Gulfstream G150

NUMBER 150-52-188

DOORS (ATA 52) – MAIN ENTRANCE DOOR
(MED) – AIRSTAIR – INTERNAL MICROSWITCH
ADJUSTMENT

JANUARY 15, 2016

Airstair Door Internal Microswitch - Adjustment
Figure 1 (Sheet 1)

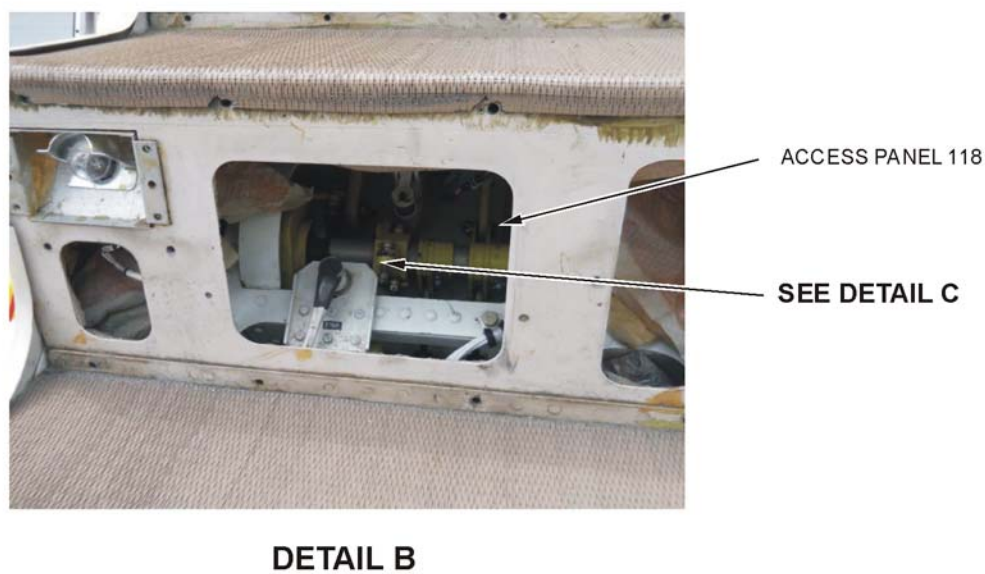
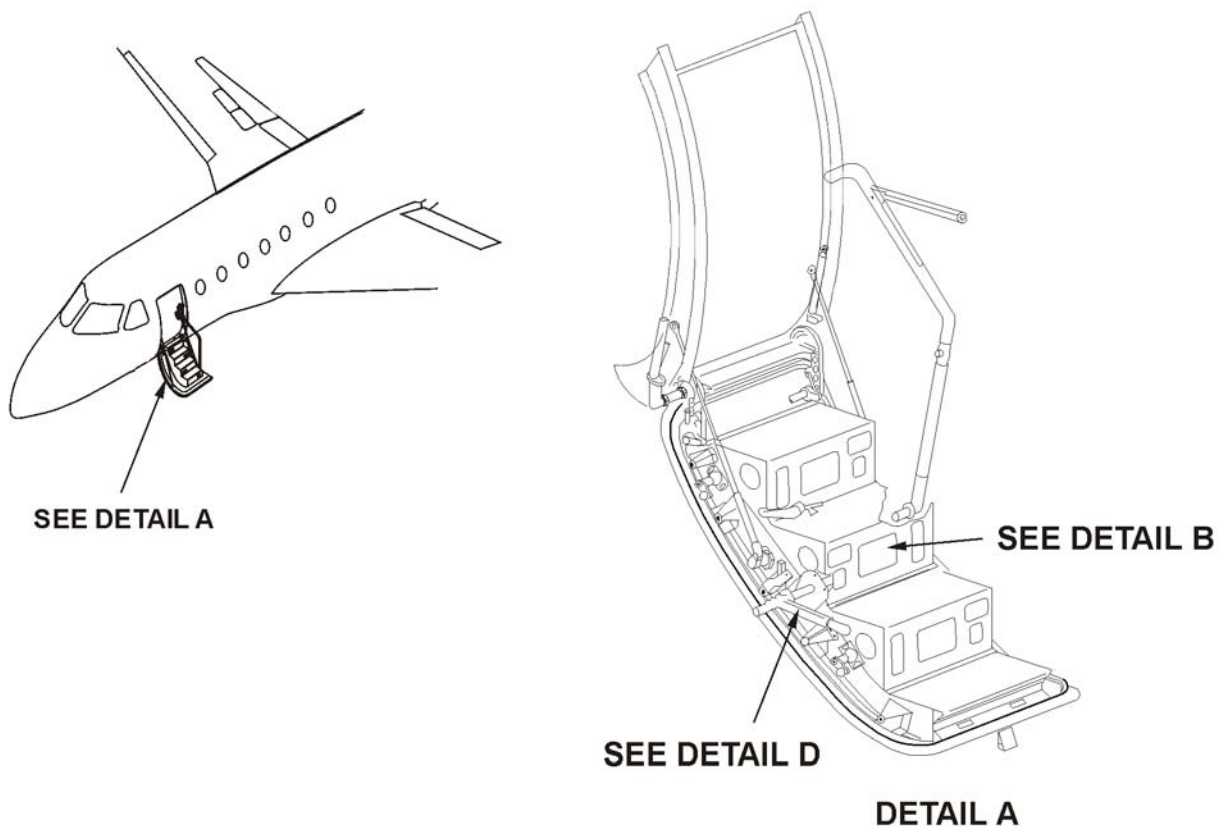
1. Prepare aircraft for safe maintenance. Refer to AMM, Safe Ground Maintenance Procedure, Chapter 20.
2. Connect electrical power to aircraft. Refer to AMM, Chapter 20.
3. Perform door airstair inner microswitch, 276H, (3) updated rigging adjustment procedure, as follows (refer to Figure 1):
 - A. Open door and remove access panel 118 from door to access the inner door microswitch (3). Refer to Figure 1, Sheet 1 and 2.
 - B. Pull, tag and install safety clip on Circuit Breaker (CB) 6L on left DC power box in equipment compartment. Refer to AMM, Chapter 24.
 - C. Remove safety wire from jam nut (2). Refer to Figure 1, Sheet 2.
 - D. Hold microswitch (3) securely and remove jam nut (2) at bracket (4). Refer to Figure 1, Sheet 2.

Airstair Door Internal Microswitch - Adjustment
Figure 1 (Sheet 2)

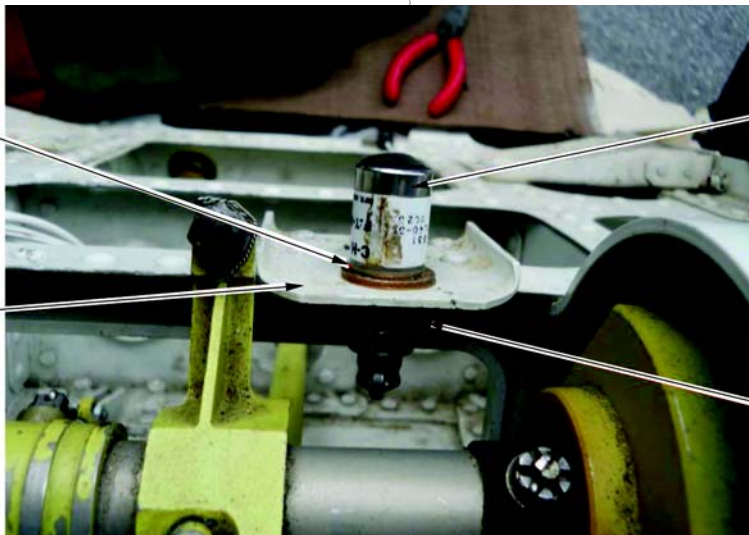
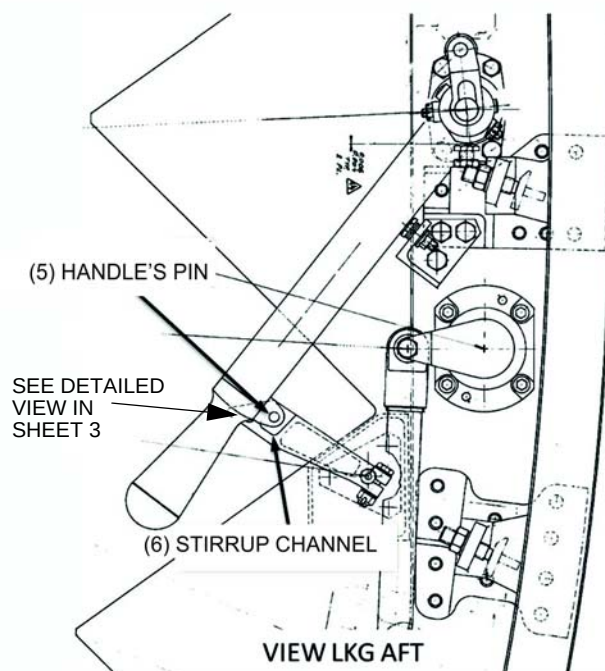
- E. Add washers (1), P/N NAS1149G0832P and NAS1149G0816P between microswitch, 276H, (3) and bracket (4), so that when the door handle is rotated to the locked position the CABIN DOOR UNLOCK message on CAS should be displayed. Tighten jam nut (2) after each installation of additional washer. Refer to Figure 1, Sheet 2.

- F. Remove washers, P/N NAS1149G0816P, one by one until a combination is obtained that, when the door is closed and the handle latch pin is fully engaged within the stirrup channel, the CABIN DOOR UNLOCK CAS message is extinguished. Refer to Figure 1, Sheet 2, Detail D.

- H. Remove one more additional washer (1), P/N NAS1149G0816P, 0.016 inch thick.
- I. Verify the CABIN DOOR UNLOCK CAS message extinguishes only after the stirrup has come up and the handle latch pin is fully engaged in the stirrup channel. Refer to Figure 1, Sheet 2.

- M. Ensure CABIN DOOR UNLOCK message on CAS is extinguished.
- N. Secure jam nut (2) with safety wire, P/N MS20995C32. Refer to Figure 1, Sheet 2.

Airstair Door Internal Microswitch - Adjustment
Figure 1 (Sheet 3)

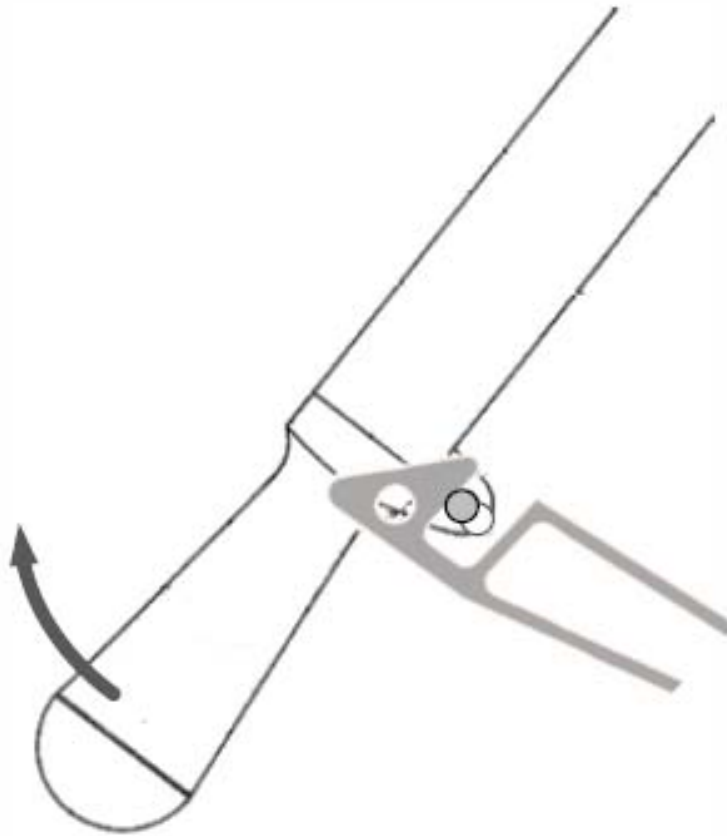
- G. Depress lever on aft side of door and rotate the handle towards the unlocked position until it contacts the stirrup. Ensure the CABIN DOOR UNLOCK CAS message is not displayed. Refer to Figure 1, Sheet 3.

- (1) If CABIN DOOR UNLOCK message displays, add back the washer (1), P/N NAS1149G0816P that was removed in Step 3.H. above.
- J. Depress lever on aft side of door and rotate the handle towards the unlocked position until it contacts the stirrup. Ensure the CABIN DOOR UNLOCK CAS message is not displayed. Refer to Figure 1, Sheet 3.
